IN THE DRAWINGS

REMARKS/ARGUMENTS

Applicants have studied the Office Action dated June 13, 2005 and have made amendments to the claims. It is submitted that the application, as amended, is in condition for allowance. Claims 4-5 and 15 have been cancelled without prejudice. By virtue of this amendment, claims 1-3, 6-14 and 16-20 are pending. Claims 1, 6-9, 12, and 16-18 are amended. Reconsideration and allowance of the pending claims in view of the above amendments and the following remarks is respectfully requested.

FIG. 2

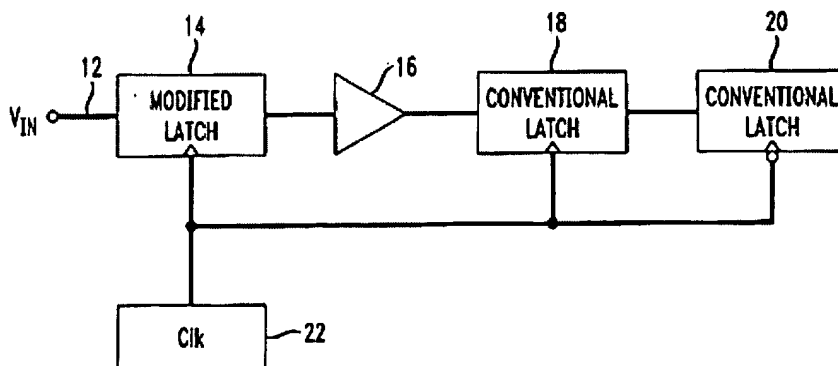
The Chen et al. reference discloses a latch chain with improved input voltage sensitivity. Chen et al. provides a modified latch that is more sensitive to input voltage than a pair of conventional latches that are provided downstream from the modified latch and an amplifier. In Chen et al., all three latches are run from a single output of a clock (22). See, Chen et al., FIG. 2.

Each of the latches (14, 18, & 20) of Chen et al. has a sample period and a hold period triggered by signals from an external clock (22). Chen et al., col. 2, lines 25-26. The Chen et al. circuit is shown below:

The Examiner on page 5 of the Office action analogizes conventional latches 18 and 20 of Chen et al. to latch circuit 512 and strobe circuit 300 of the present invention,

respectively. Although it is not mentioned in the specification, the above circuit of Chen et al. shows an important feature that would make any type of a delay element in the clock signal line between conventional latches 18 and 20 of Chen et al. render the circuit inoperable. FIG. 2 of Chen et al. shows an inverter at the clock input to the latch 20. The inverter ensures that while the first conventional latch (18) is holding, the second conventional latch (20) is sampling. When the clock cycle switches, the second conventional latch (20) holds the previously held output value of the first conventional latch (18) and the first conventional latch (18) begins sampling again. A delay element inserted in the clock signal line between the first latch and second latch, as the Examiner suggests would be obvious, would destroy the intent of Chen et al. because the signal previously held by the first latch would be gone by the time the second latch was signaled to hold.

With regards to further teachings contained in the above circuit of Chen et al., the input signal V_{IN} 12 is delayed by the modified latch 14, and the buffer 16, prior to being provided to the conventional latch 18. The delay of buffer 16 is designed to match the delays of the other latch circuits. Chen, et al. column 3, lines 24-40. Chen et al. further teaches an embodiment wherein cascaded amplifiers are used to generate a proper delay. Chen et al., column 3, lines 41-51 and FIG. 3. A delay element inserted in the clock signal line between the modified latch 14 and conventional latch 18, would destroy the intent of Chen et al. because the Chen et al. system is based upon the delay being provided by amplifier 16. In addition to destroying the intent of Chen et al., such a combination would be inoperable due to the fact that the delay provided amplifier 16 of Chen et al. requires an undelayed clock to be delivered to latch 18.

FIG. 1

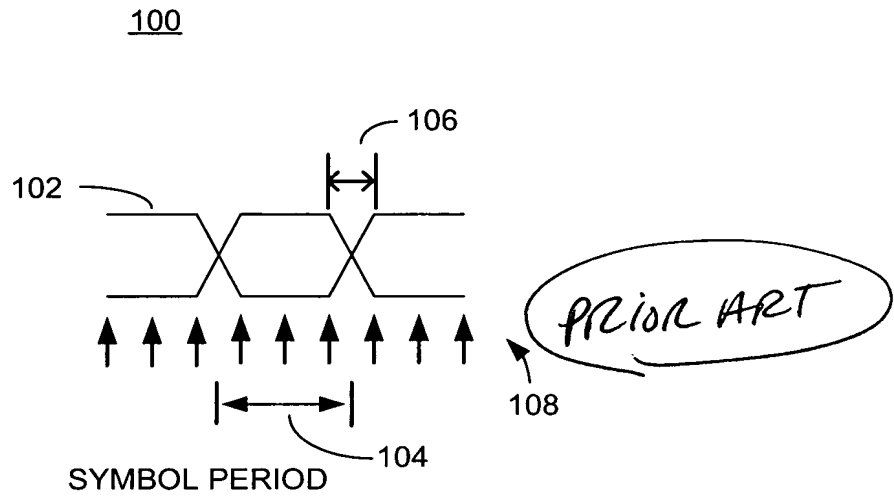
- FIGs. 1-4 add the legend "Prior Art".

As noted above, the Examiner objected to drawings 1-4 under MPEP § 608.02(g) for omitting the legend "Prior Art". In amended Figures 1-4, the previously omitted legend "Prior Art" has been added. As required under 37 CFR 1.84 "Annotated Sheet Showing Changes" and Replacement Sheets are attached hereto. Applicants submit that the Examiner's objections to the Drawings have been overcome and the Examiner's rejection should be withdrawn.
